DESCRIPTIVE REPORT

Registry No. F00464

Locality DETROIT AND ST. MARY'S RIVERS

ATLANTIC HYDROGRAPHIC BRANCH
EVALUATION REPORT FOR F00464 (2000)

FE00464
OPR-W408-NRT1
St. Mary's River - Michigan
Section from Chart 14882
NOAA Launch 517
300% SSS Coverage

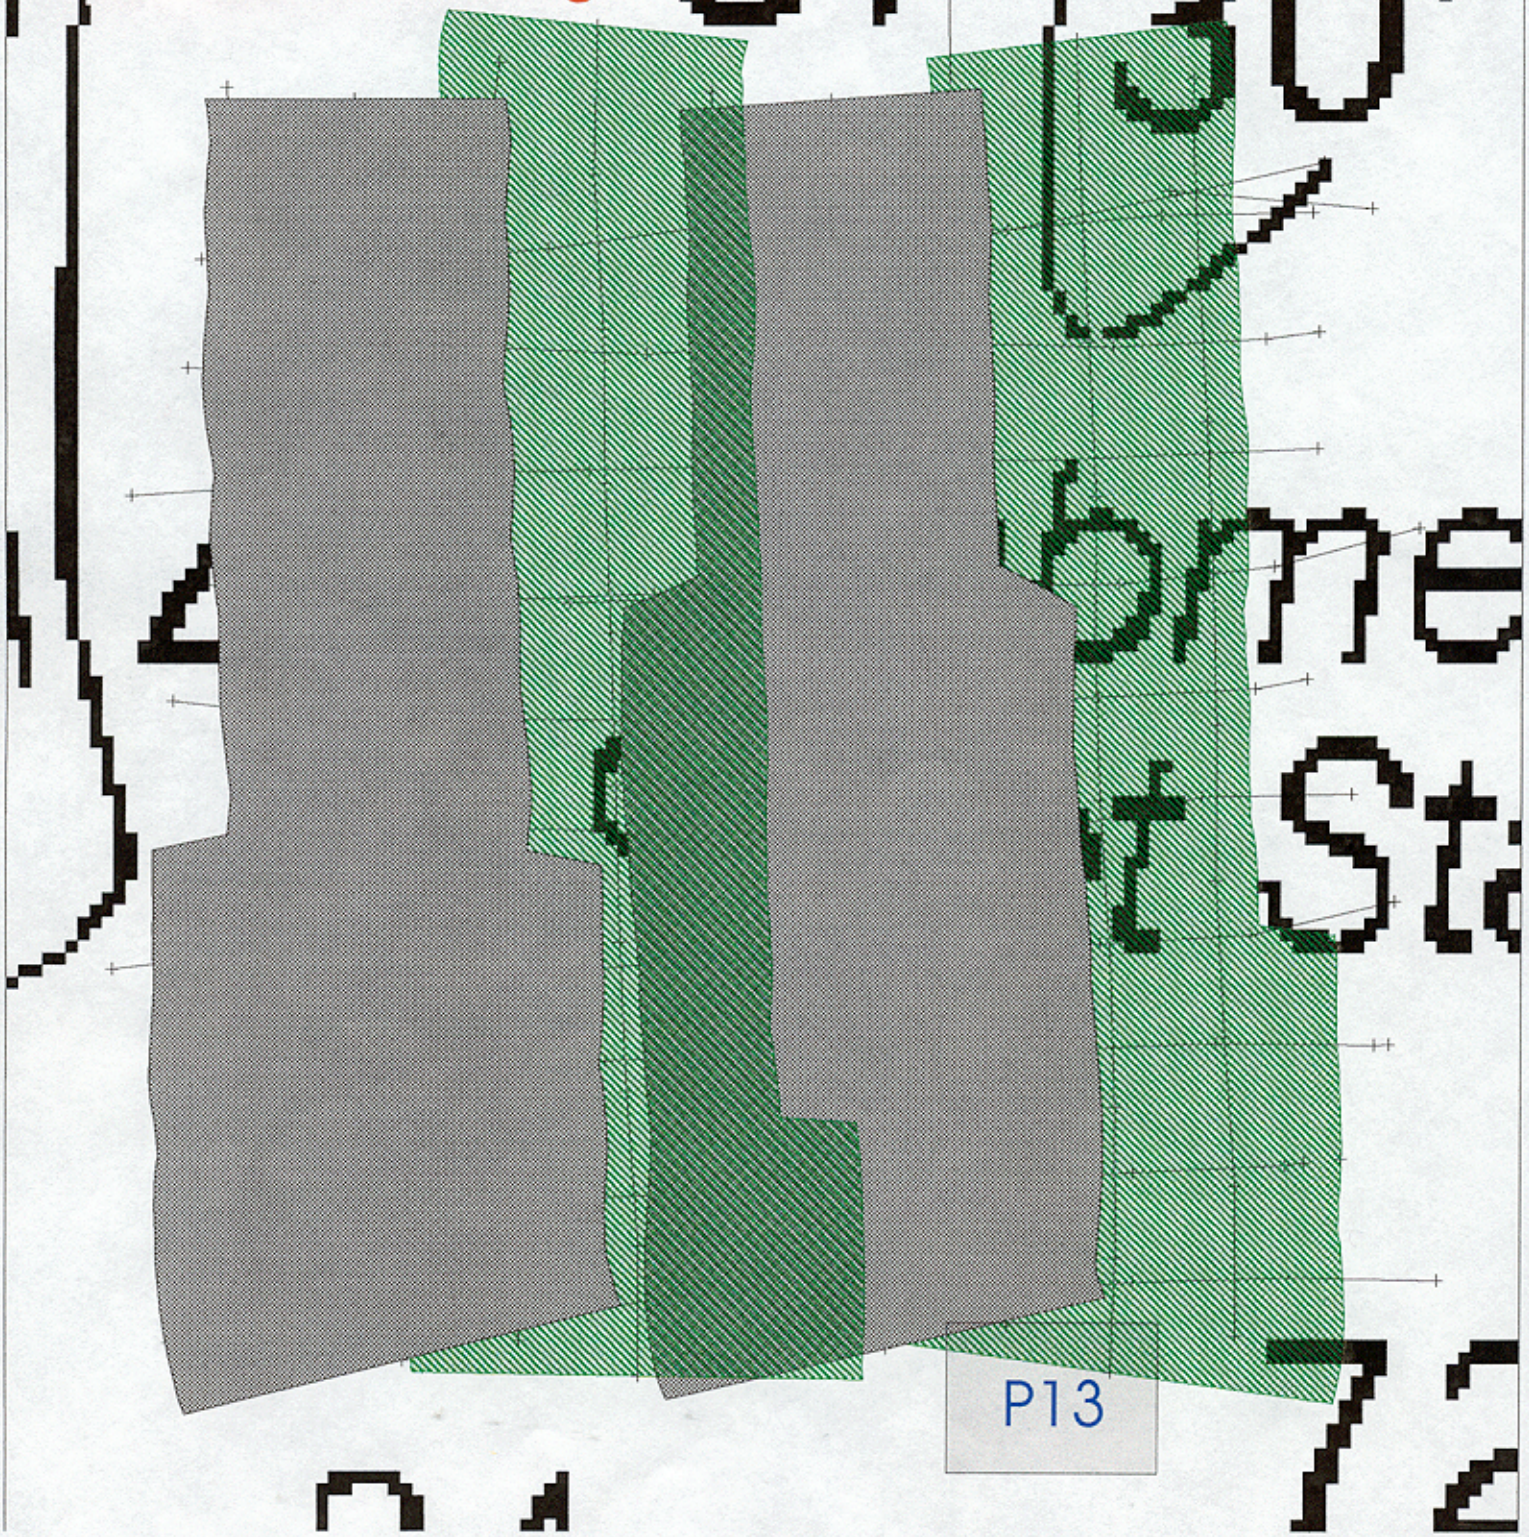
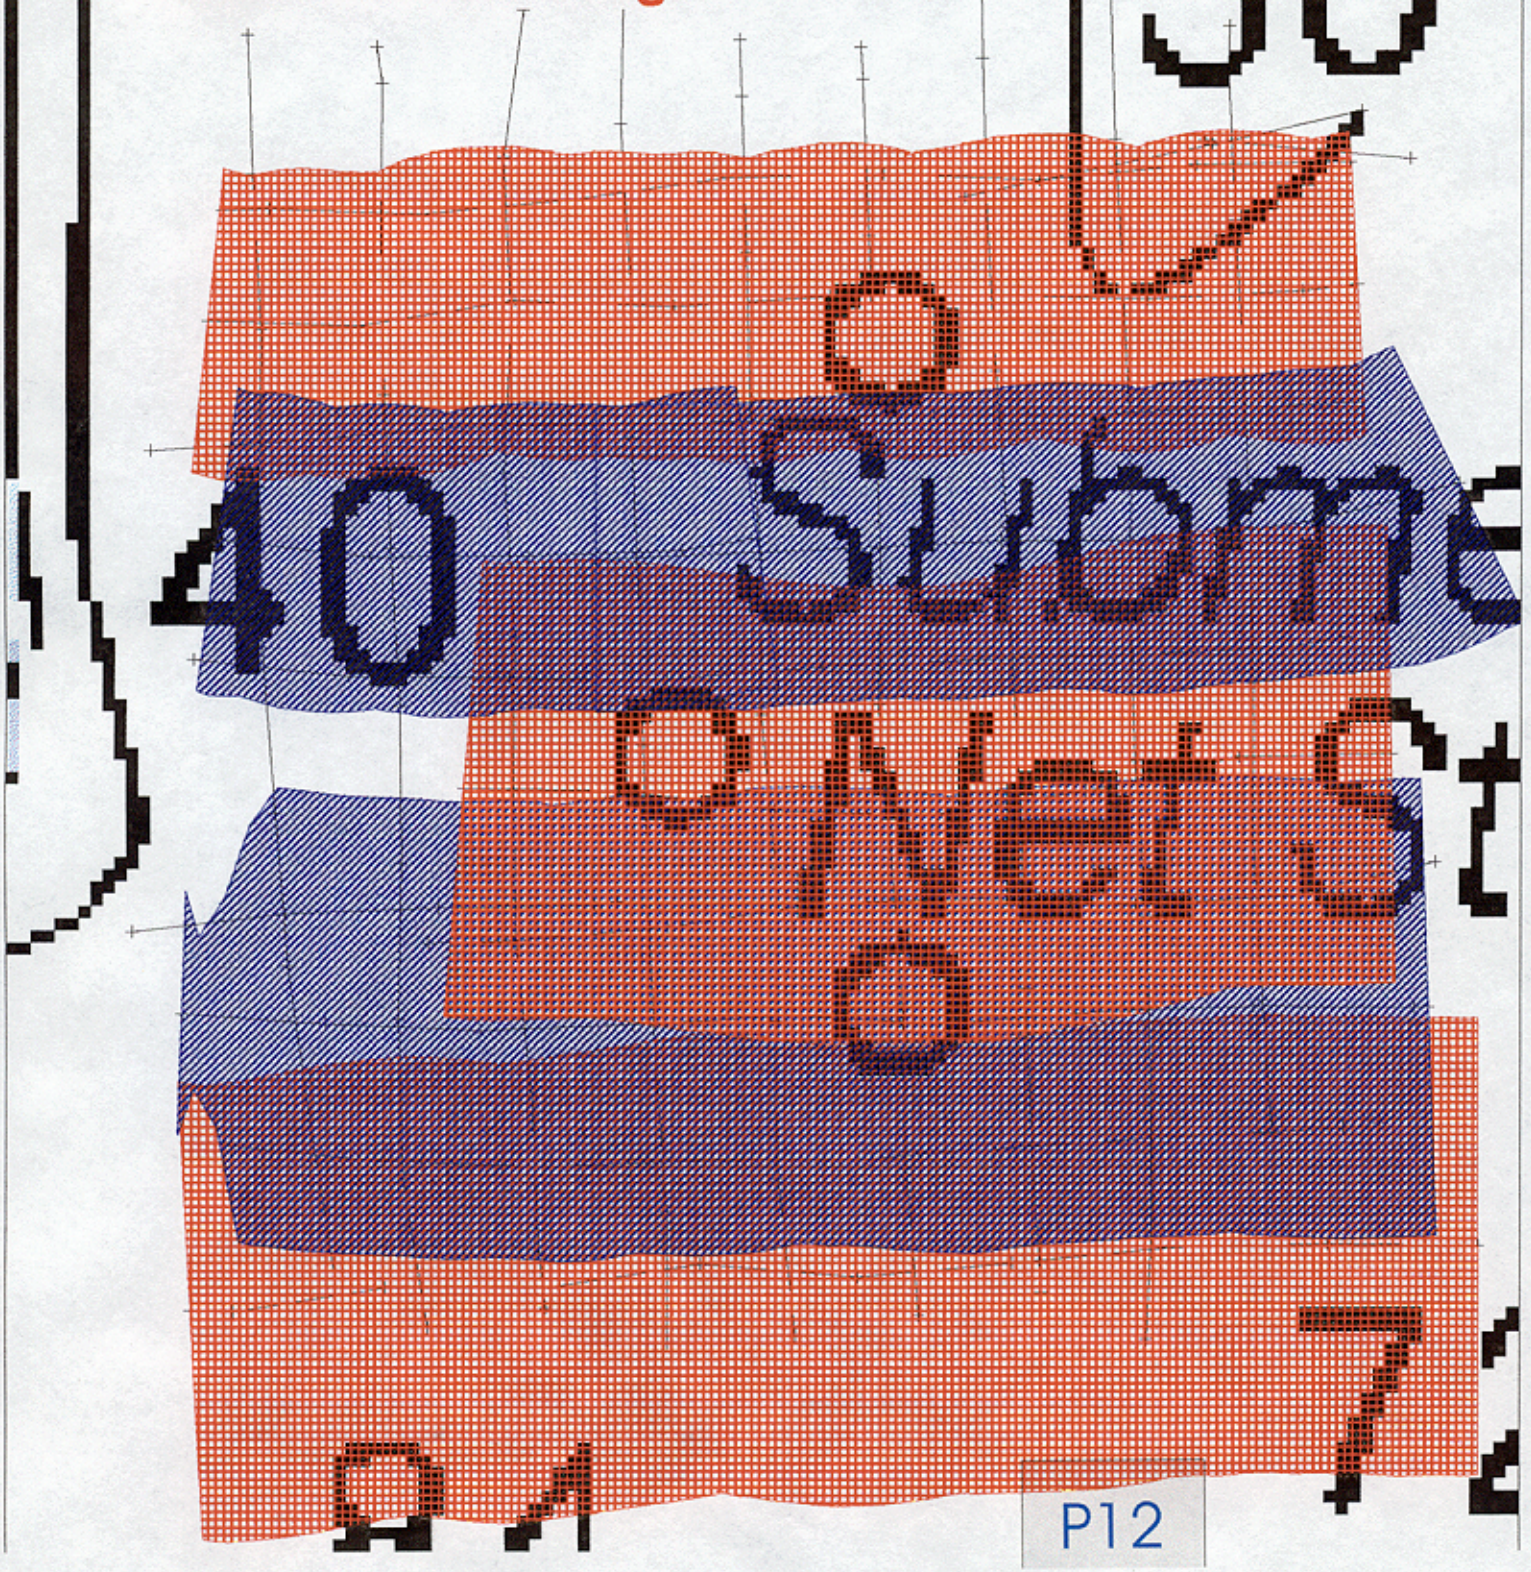
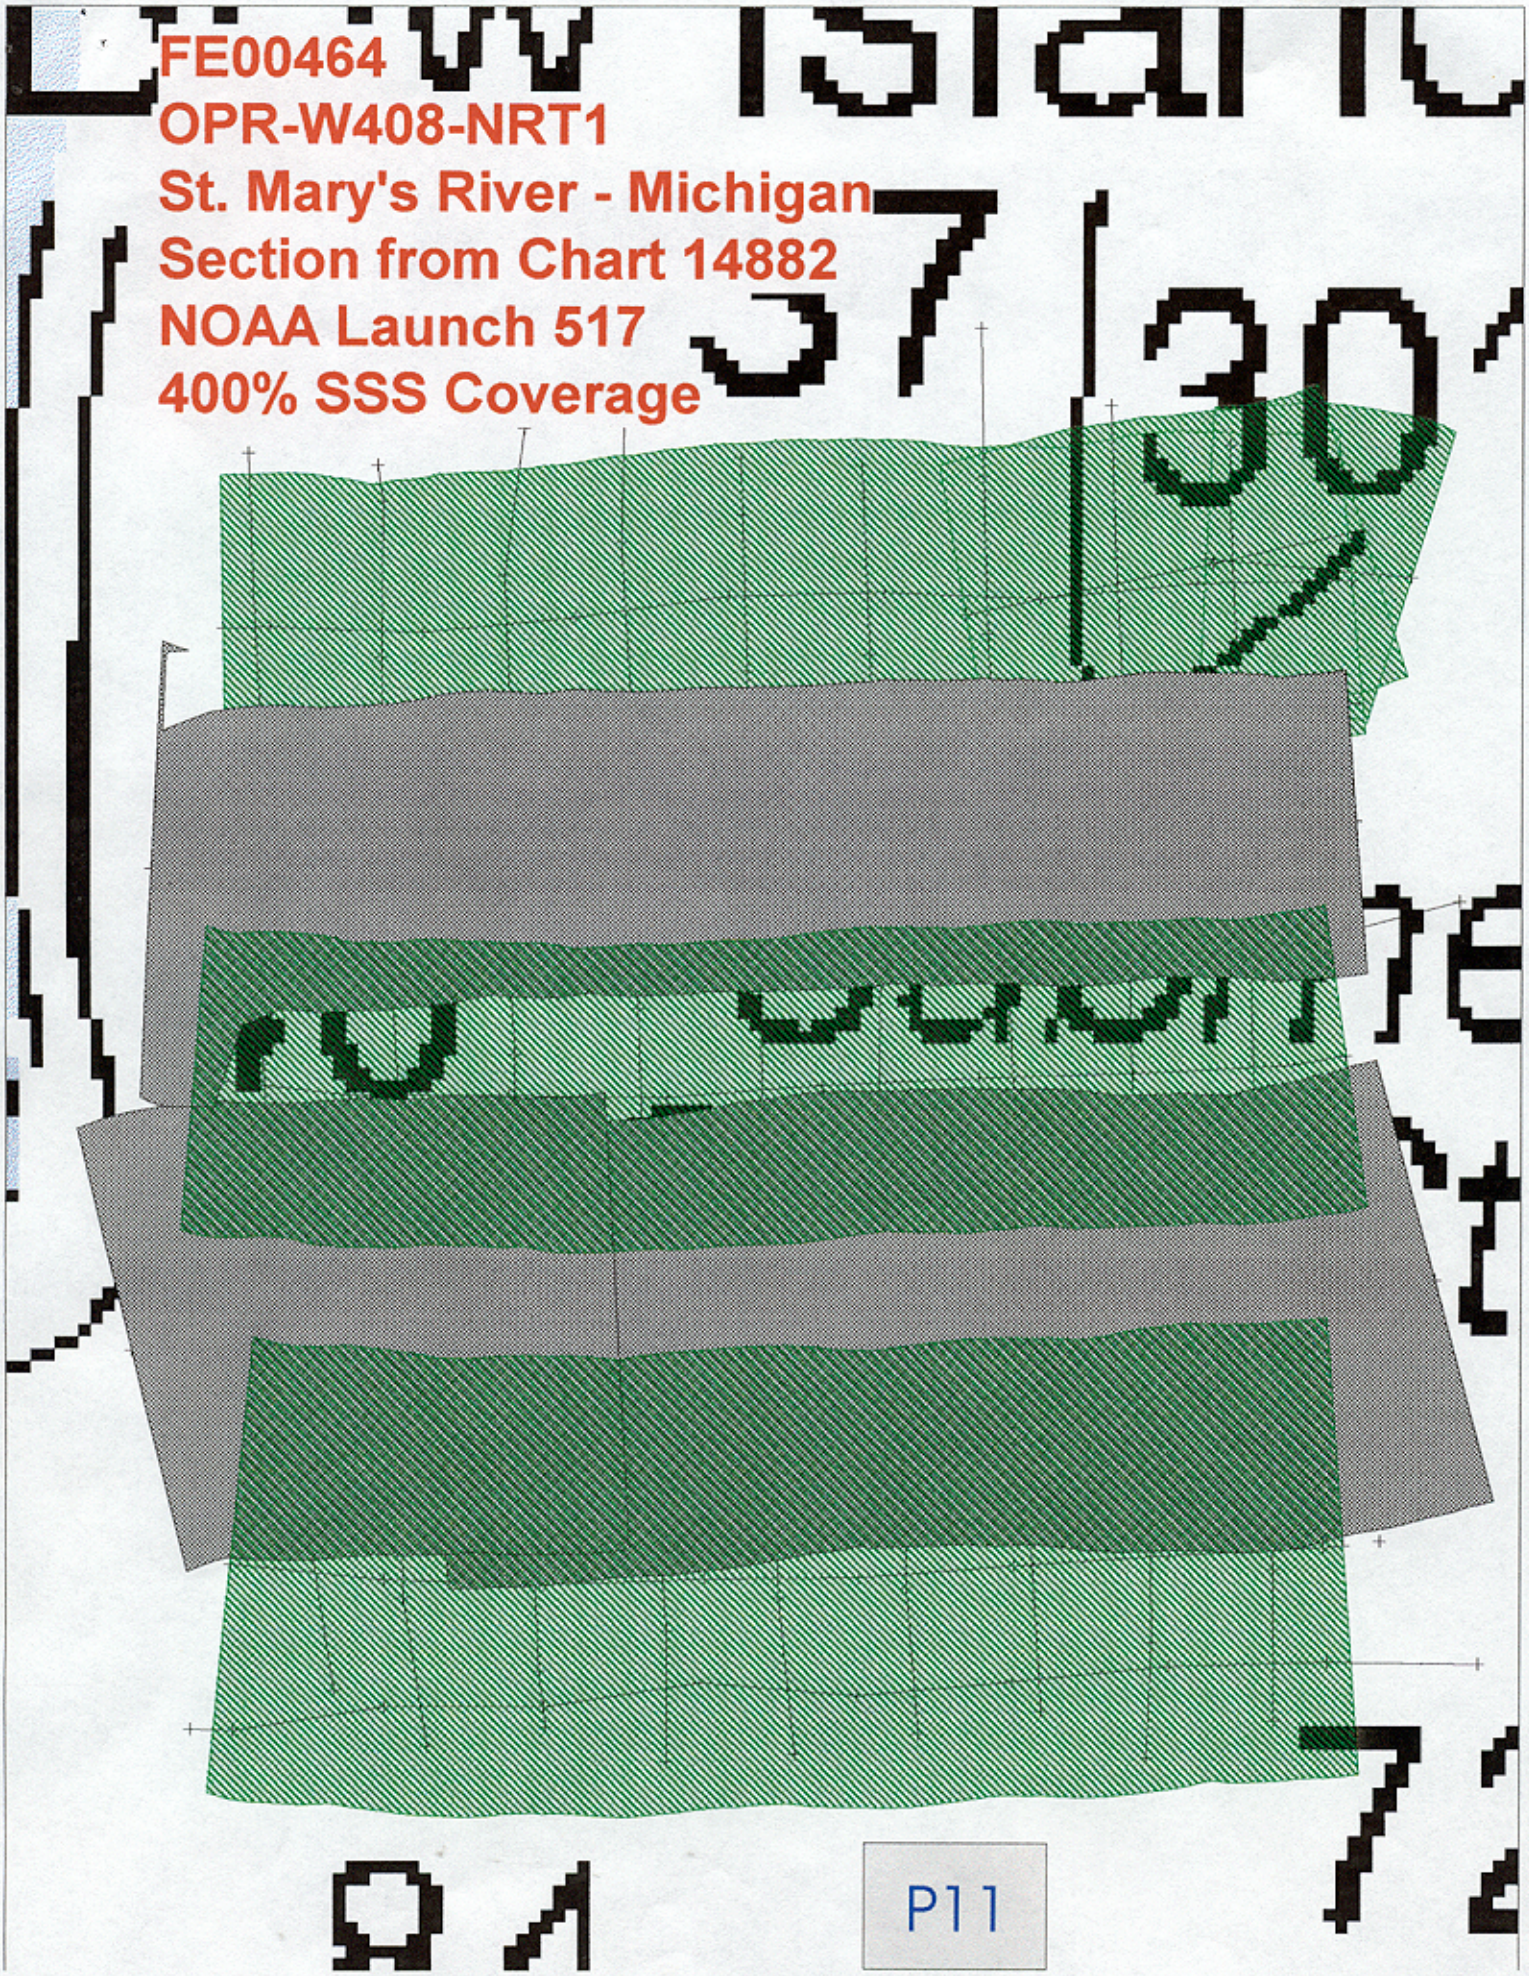
Feature 10 was investigated with 400% coverage side scan sonar. Nothing was found. Sounding, trackline, and swath plots are included with this survey. Concur (1) Plots associated with this item are appended to This Report. See E+A Report Sect D1.H.1. page 4.

1) ENC FEATURE #10 was assigned to verify the

existence of the "submerged net stakes" charted in the vicinity of Latitude 46°02'05.32"N, Longitude 83°49'23.05"W. The field acquired 400% side scan sonar coverage over the charted stakes with negative results. No indication of the submerged net stakes was found by the present survey. It is recommended that the symbols and labels for the "submerged net stakes" be removed from the chart. Also, reposition the (see note D)note in the vicinity of this item. Field plots P9 - P15, appended to the end of this report, show the field work done on this item.
